# Final TAB Punchlist

**5774 Burlington (IA) FSU**

L1020005774

## #139 [CURT 503] [NEW] Air curtain door switches.

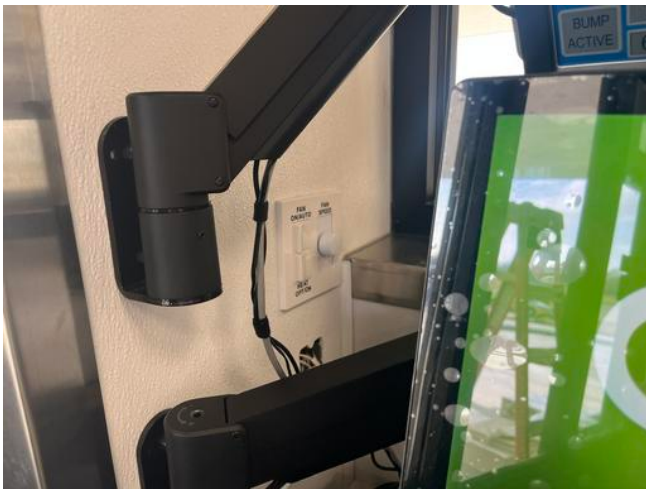
Air curtain magnetic door switches are not installed correctly or not properly controlling mode activation in Auto at time of TAB inspection.

**#136 [UNIT 501] [NEW] Equipment low voltage diagrams**

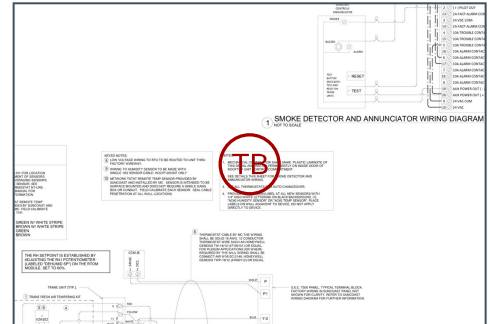
Equipment missing  
laminated copy of controls  
detail low voltage wiring  
diagrams.
